wood.	ADNOC GAS LONG TERM - EXECUTE STAGE PROJECT 5.0 (P5) EPCm FOR HABSHAN DBN COMPANY PROJECT No. 30201-50150-LT-HE WORK ORDER NO. 3000076501

Comments Resolution Sheet (CRS) - EPCm

COMPANY Trans. No.:	ADNOCGP-WTRAN-023937	Received Date:	2-Feb-26
COMPANY Doc. No.:	30201_50150_LT_HE-H4-280-17-23-001	Revision:	B
Document Title:	UNIT 280 -HABSHAN 4 FOUNDATIONGA & DETAILS SUBSTATION SS-201	Status Code:	2
ADNOC PM:	Dr Azharuddin Mohammed	EPCm. CONTRACTOR PM:	Shailesh
ADNOC Reviewer:	Mr Vinodhkumar Ranganathan	EPCm. CONTRACTOR Originator:	Hamed Gholampour

DRAWING TITLE: UNIT 280 –HABSHAN 4 FOUNDATION GA & DETAILS SUBSTATION SS-201 BUILDING FOUNDATION LAYOUT

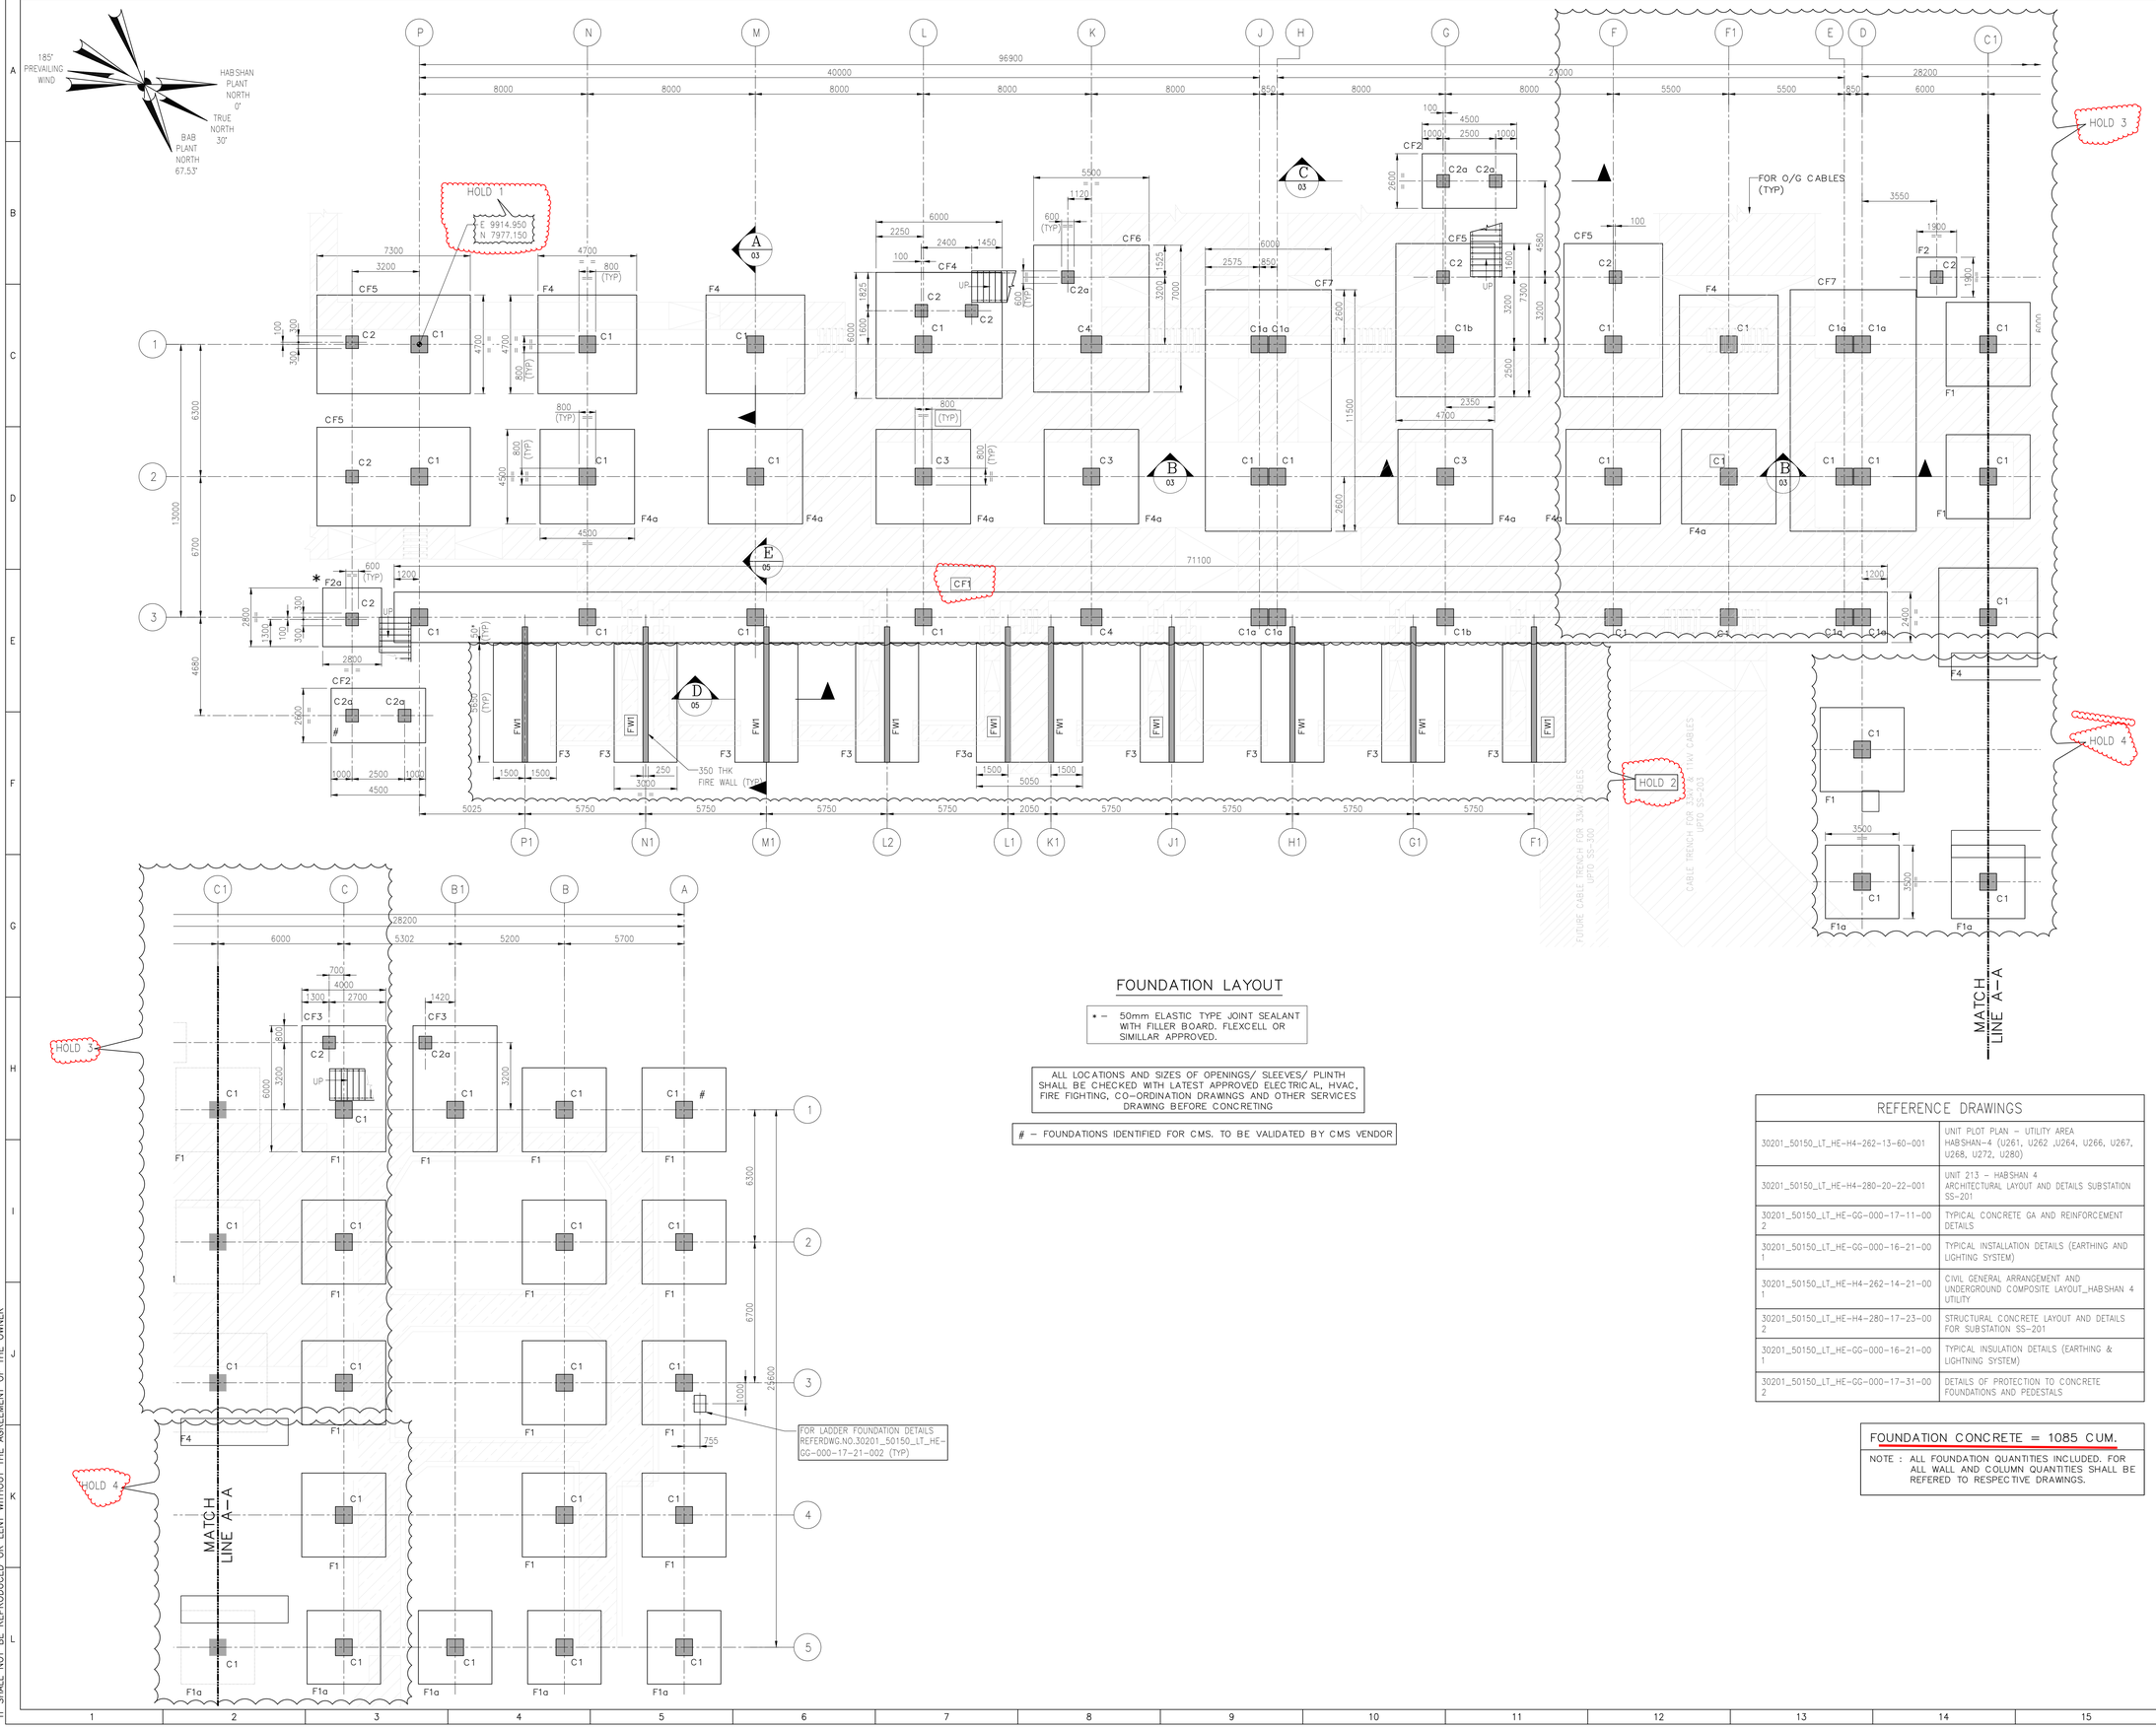
No.	COMMENT SECTION/ CLAUSE / DRAWING REFERENCE	COMPANY Comment	COMPANY Reviewer	EPCm CONTRACTOR Response	Open/Closed	COMPANY Response (If Comments are still open / Not incorporated or if Eng Contractor Response Not Acceptable)	EPCm CONTRACTOR Response	Open/Closed	Remarks
1	30201_50150_LT_HE-H4-280-17-23-001-01	Refer 30201_50150_LT_HE-H4-280-17-23-003 and update for the typical comments and presentation	Mr Vinodhkumar Ranganathan	Noted and Updated					
2	30201_50150_LT_HE-H4-280-17-23-001-02	Check the correctness of type and update		Noted and Updated					
3		For cellar room , foundation and column size may be optimized. check and update. Typical comment		Noted. SBC very low as per the latest geotechnical report, optimization done as much poosible.					
4		Check the correctness and update		Noted and Updated					
5		Same foundation size considered in all the columns. check and update to optimize		Noted and Updated

Updated					
8		Refer Execute stage interpretative report and update as required. There is a change in SBC.		Noted. Foundations updated for the SBC, as per the new geortechnical report.					
9		check to optimize and update as required		Noted and Updated					
10		check whether this is applicable for this area and update		Noted and Updated					
11		Refer SS#203 drawing and update in same manner		Noted and Updated					
12	30201_50150_LT_HE-H4-280-17-23-001-03	Update to show the Joint details to execute together with concrete casting		Noted and Updated					
13		For combined foundation, top rebar in critical. check and update		Noted and Updated					
14		update to provide the rebar plan		Noted and Updated					
15		T12 may be sufficient for side face rebars		Noted and Updated					
16		As discussed, ensure to provide side face rebar at a spacing < 300mm.		Noted and Updated

DRAWING TITLE: UNIT 280 –HABSHAN 4
FOUNDATION GA & DETAILS SUBSTATION SS-201
FOUNDATION SECTIONS & DETAILS

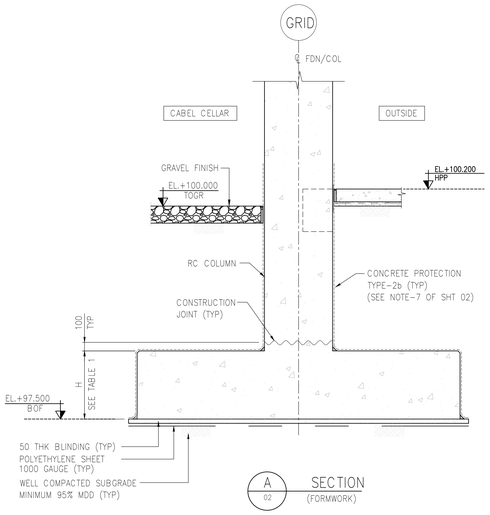
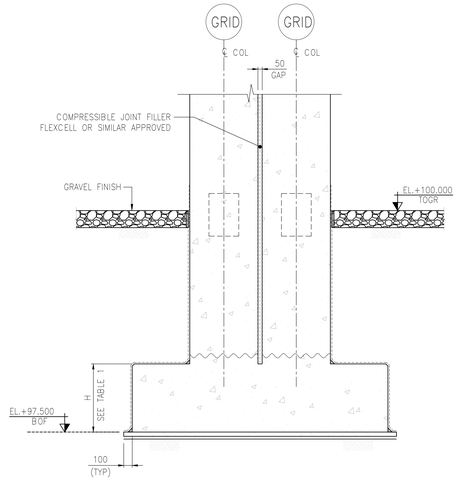
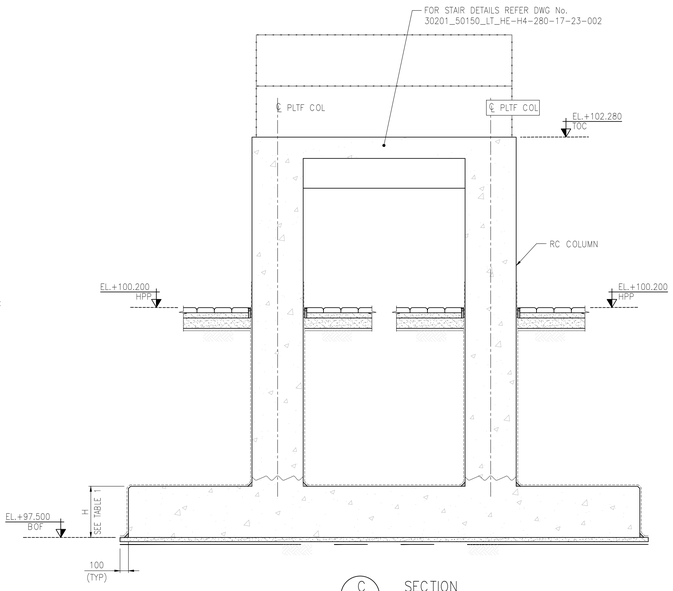
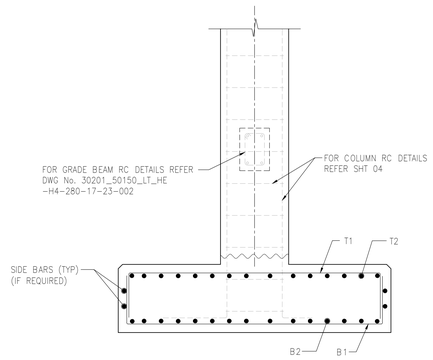
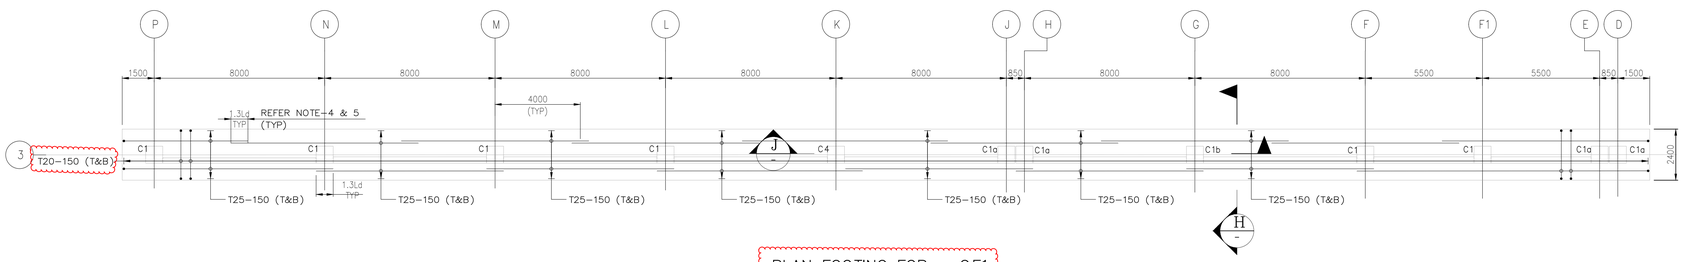
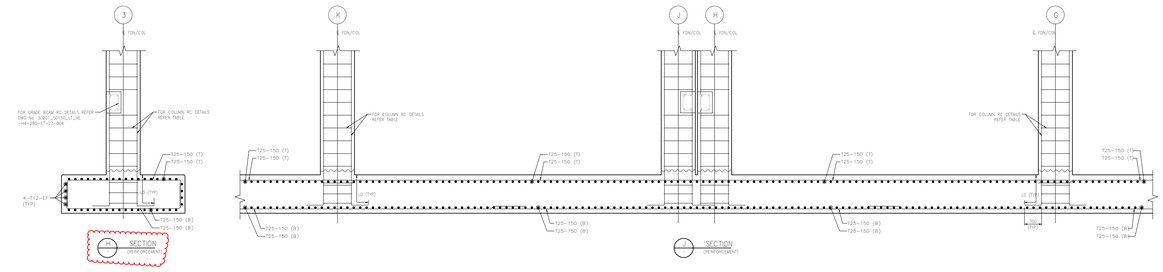
31	30201_50150_LT_HE-H4-280-17-23-001-03	Reinforcement details shown are not matching with calculation report. Check and ensure to align with design calculation. Typical comment for all columns	Mr Mandar Nadgouda	Noted & incorporated					
32		Show near trench also to clarify that ir is clearing foundation (typ.)	Mr Abhishek Srivastava	Will be shown after finalization of trenches location.					
1		Horizontal rebars shall be on the external. Update	Mr Vinodhkumar Ranganathan	Noted & Incorporated					
2		add dimension to locate or add suitable note for locating rebar laps and staggering of splice	Mr Mandar Nadgouda	Reffer to note no.6					
3		Show side bars	Mr Mandar Nadgouda	No need to Side bar for this foundation.					
4	30201_50150_LT_HE-H4-280-17-23-001-04	Update to show the grooves	Mr Vinodhkumar Ranganathan	Will be incorporated after final architectural drawing received.					
5		This design is good for heat circulation. However, falling rain might leak on top of Transformer cable box. Hence, change as shown with slop.	Mohamed Elsadani	Will be incorporated after final architectural drawing received.

DRAWING TITLE: UNIT 280 –HABSHAN 4
FOUNDATION GA & DETAILS SUBSTATION SS–201
COLUMN SECTIONS AND RAFT FOUNDATION DETAILS

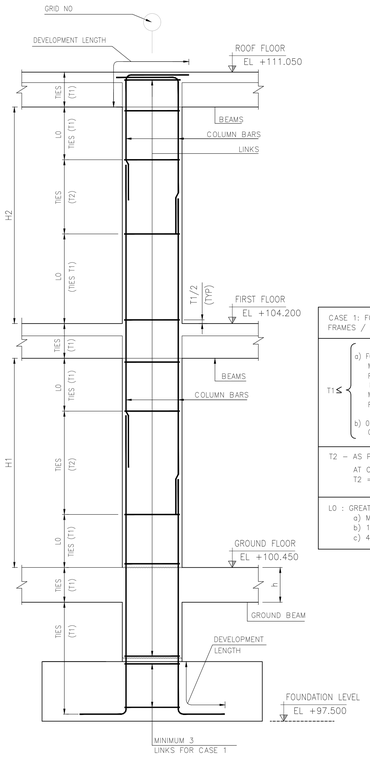
17	30201_50150_LT_HE-H4-280-17-23-001-04	SS-203 span is more or less same as SS-201. But rebar detailing is different. Check and ensure uniformity in design is maintained. update		Noted and Updated					
18	30201_50150_LT_HE-H4-280-17-23-001-05	consider cap u-bar		Noted and Updated					
19		Heavy dia. may not be required for distribution. check and update		Noted and Updated					
20		Update the Fire wall section and details same like SS-203.		Noted and Updated					
		As discussed with EPCM Architect, prepare the study sketch demonstrating the height requirement of fire wall to discuss with CPY TEs before the next submission of this drawing.		As Discussed with company, this detail to reamain as it is.					
		Please refer the E08 type standard earthing installation from drawing 30201_50150_LT_HE-GG-000-16-21-001 for REINFORCEMENT CONCRETE STRUCTURE	Mr Kiranbhai kuntmal	Noted and Updated

DRAWING TITLE
UNIT 280 –HABSHAN 4
FOUNDATION GA & DETAILS SUBSTATION SS-201
WALL SECTIONS & DETAILS

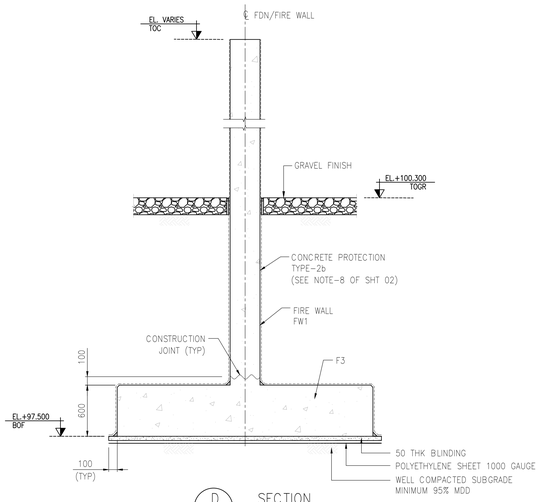
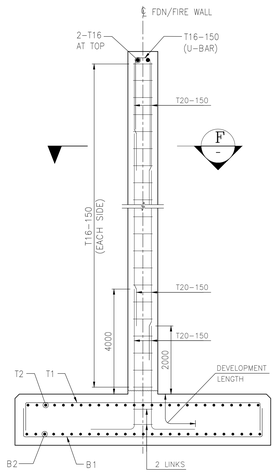
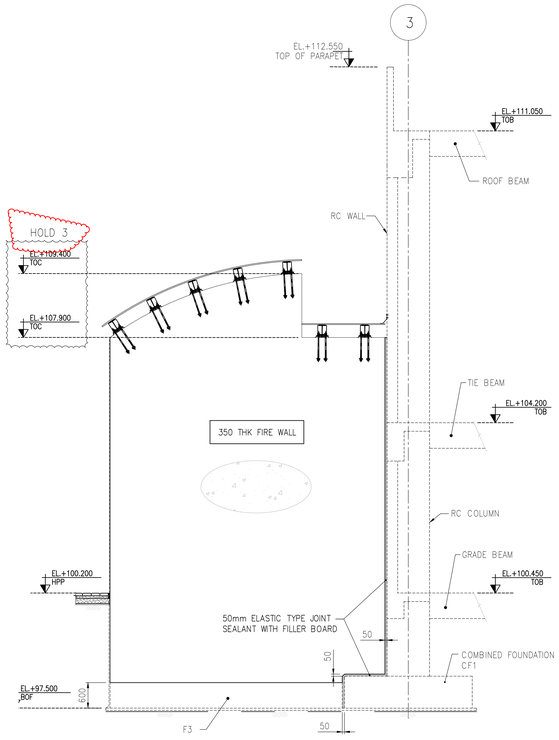
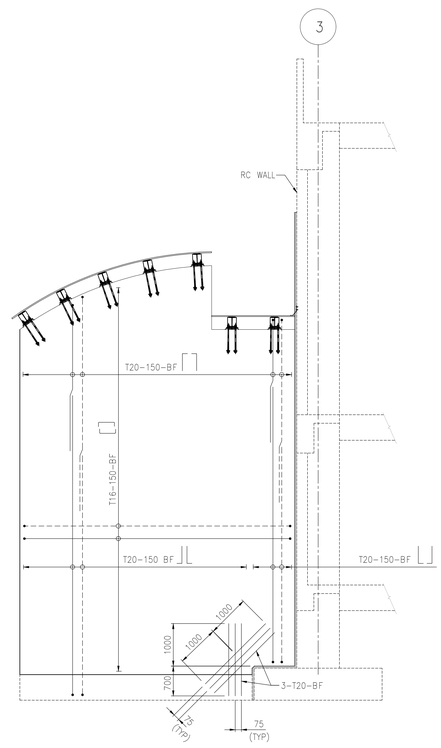
6		Ensure to extend beyond edge to ensure that rain water will drain on the sheeting, update applicable drawings	Mr Sreekanth Nuthanapati	Will be incorporated after final architectural drawing received.					
7		This design is not acceptable. why the fire wall is so high. Revise as disscussed	Mr Abhishek Srivastava	shall be incorporated in next revision.
